IN THE DRAWINGS:

REMARKS

ANNOTATED SHEET
AMAT/2622.D1/CMP/ECP/RKK
10/630,185
JULY 29, 2003
APPLIED MATERIALS, INC.
ELECTRO-CHEMICAL DEPOSITION CELL
DORDI, ET AL.

Fig. 8

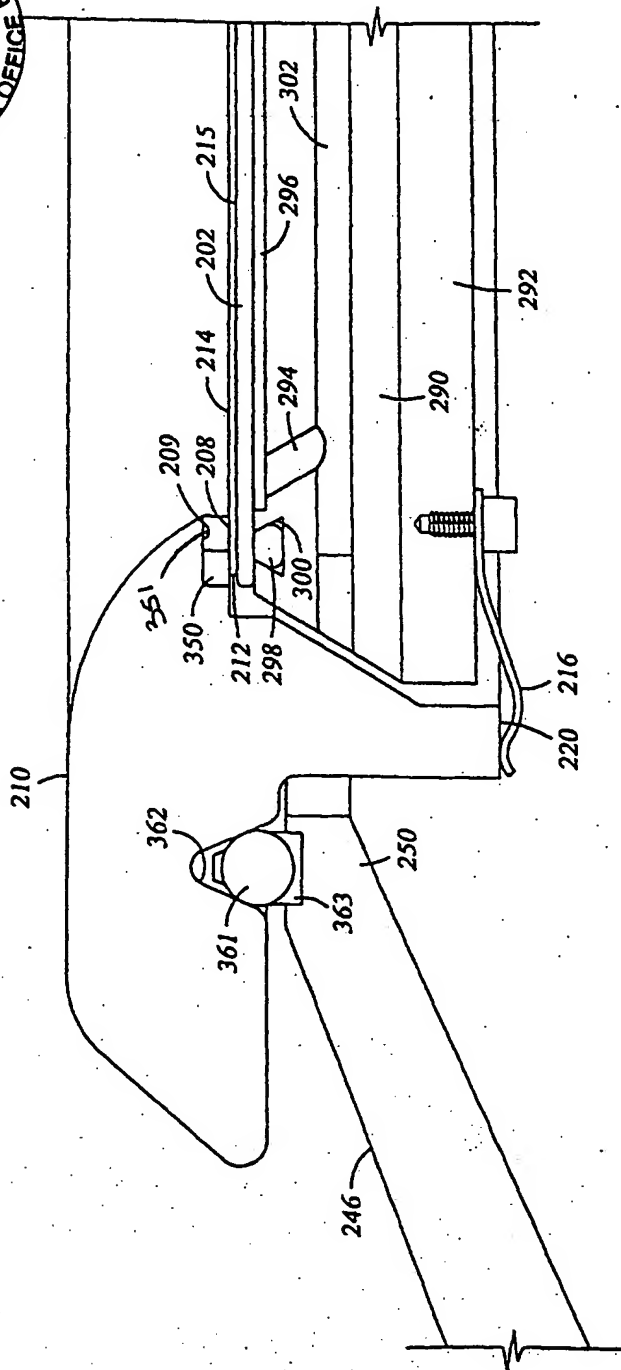
One attached sheet of drawings includes changes to Figure 8. This sheet replaces the original sheet including Figure 8. In Figure 8, element 351 has been added.

In Figure 8, element numeral 351 has been added.

Fig. 12

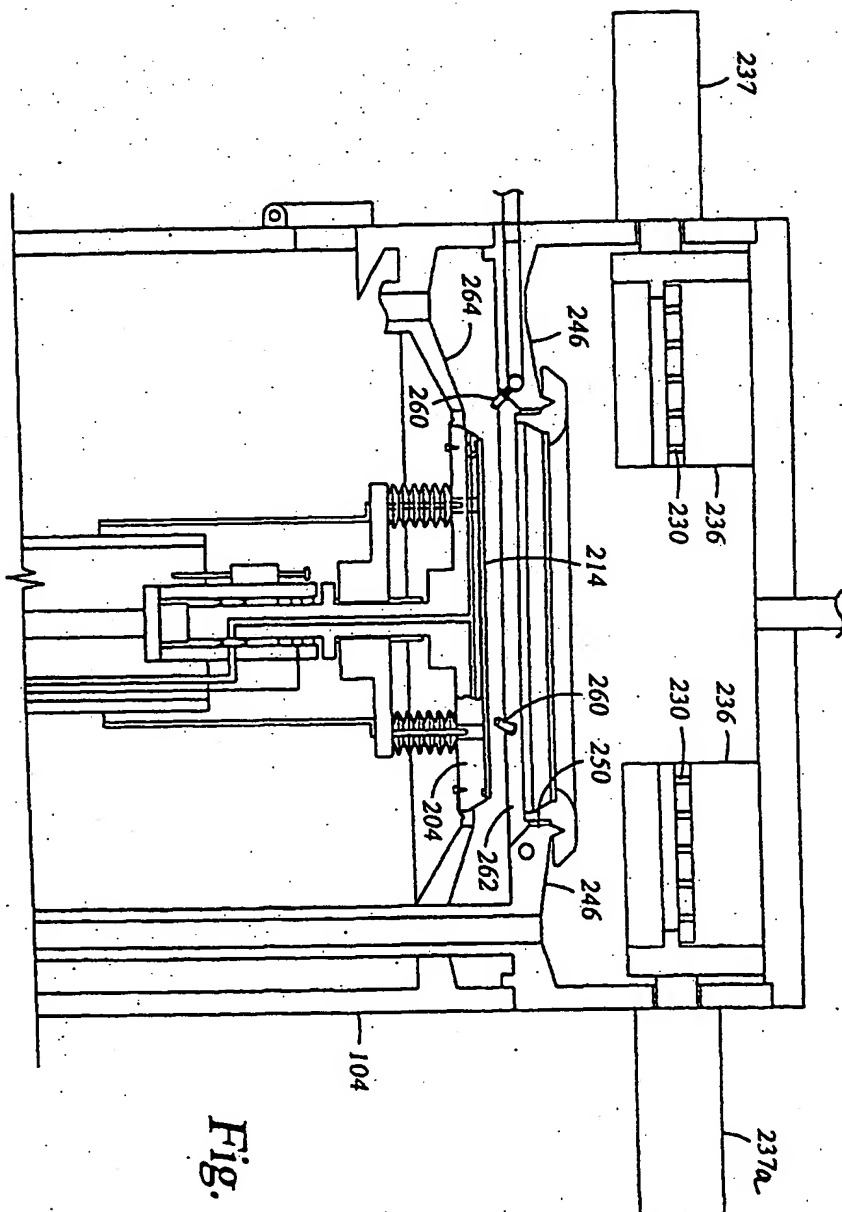
One attached sheet of drawings includes changes to Figure 12. This sheet replaces the original sheet including Figure 12. In Figure 12, element 237 has been renamed 237a.

In Figure 12, element numeral 237 has been renamed 237a.

FIG. 13

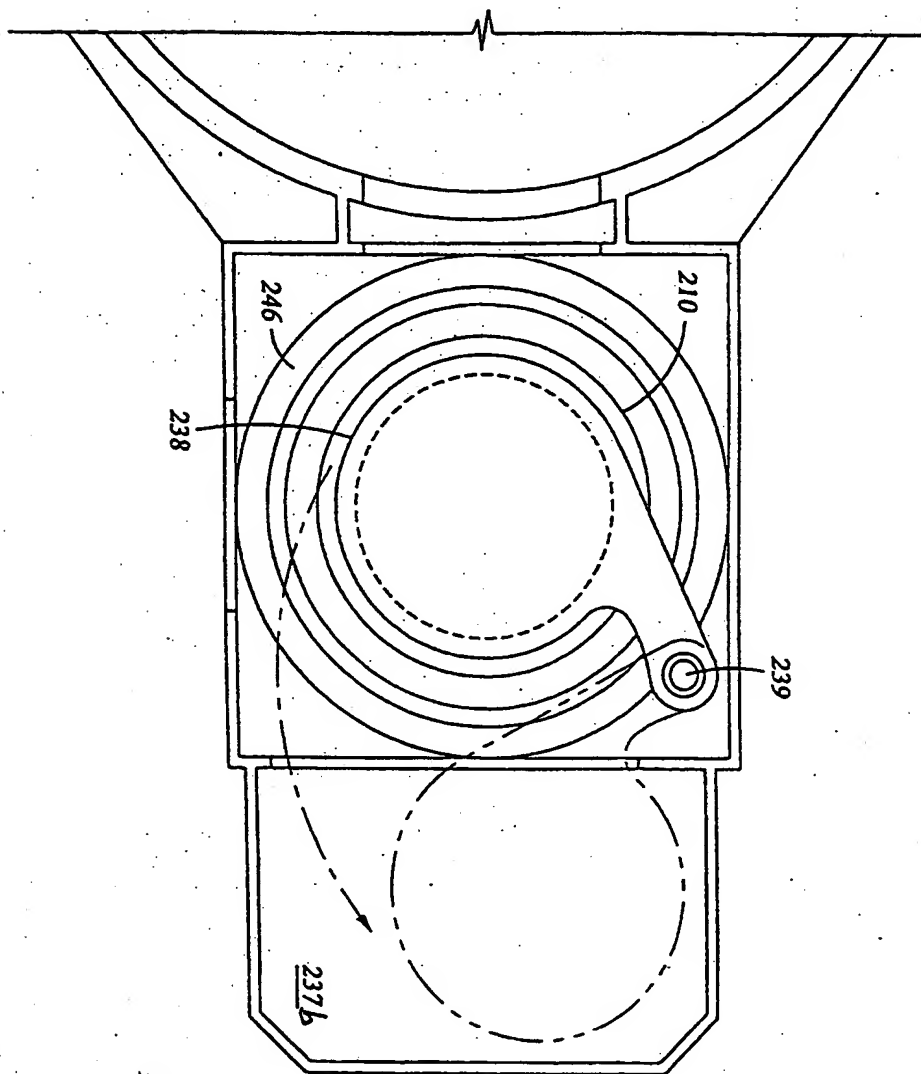
One attached sheet of drawings includes changes to Figure 13. This sheet replaces the original sheet including Figure 13. In Figure 13, element 237 has been renamed 237b.

In Figure 13, element numeral 237 has been renamed 237b.

Fig. 16

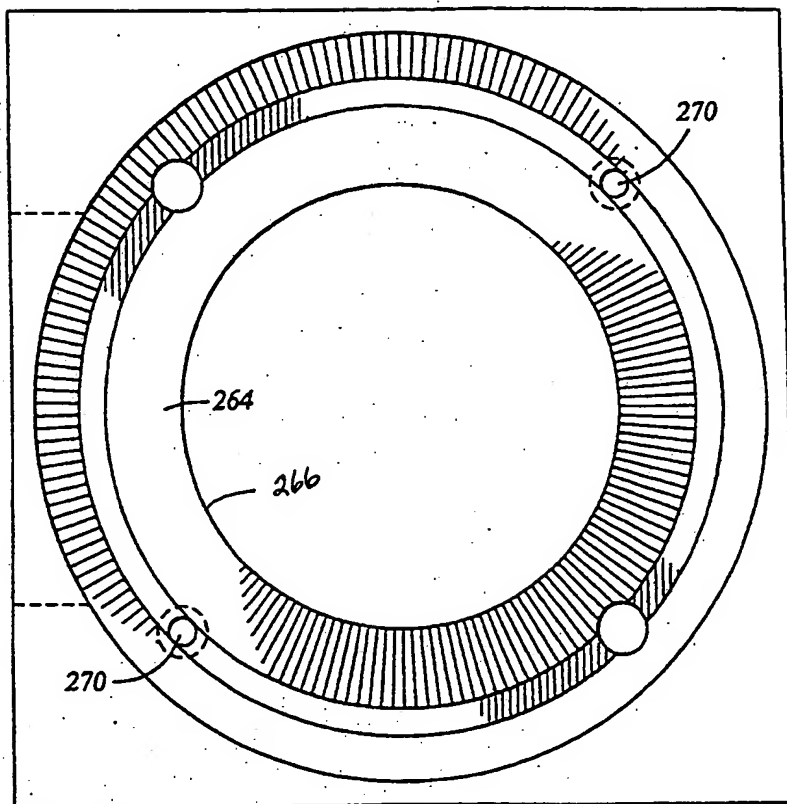
One attached sheet of drawings includes changes to Figure 16. This sheet replaces the original sheet including Figure 16. In Figure 16, element 266 has been added.

In Figure 16, element numeral 266 has been added. Claims 9 and 24 have been cancelled without prejudice by Applicant. Claims 1 - 27 stand rejected by the Examiner. Claim 28 has been added. Reconsideration of the rejected claims is requested for reasons presented below.
